ADDENDUM NO. 3

**MLK ELEMENTARY SCHOOL
TRANSITIONAL KINDERGARTEN
BAKERSFIELD CITY SCHOOL DISTRICT**

**Project No.: 5593
DSA File No. 15-6
DSA App No. 03-123900
January 24 2025**

Sheet No.:
S2.02

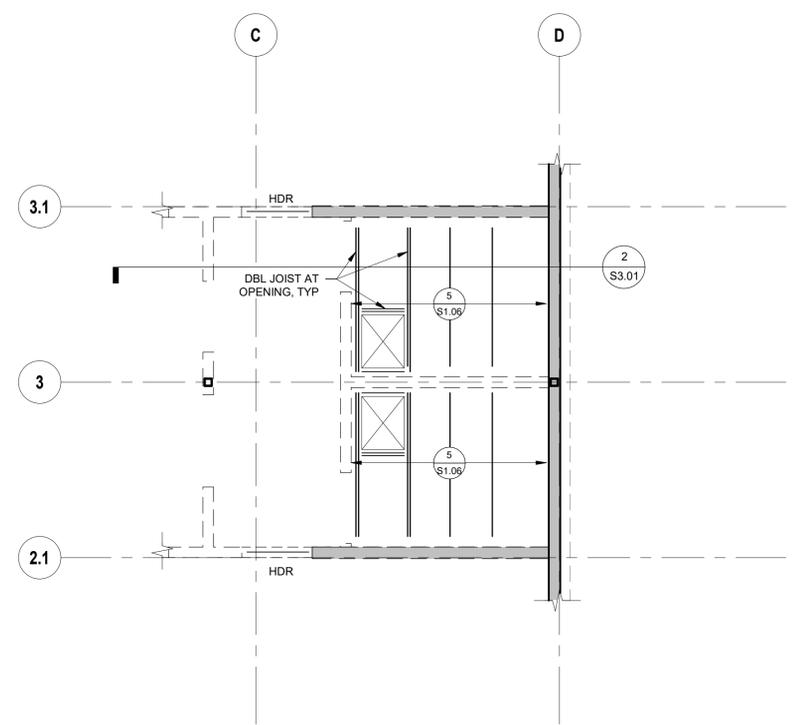
3-23 DRAWING, SHEET S2.02 – ROOF FRAMING: The HSS beam along grid line 1 and 5 are to be AESS2. See exhibit S0.02 and S2.02
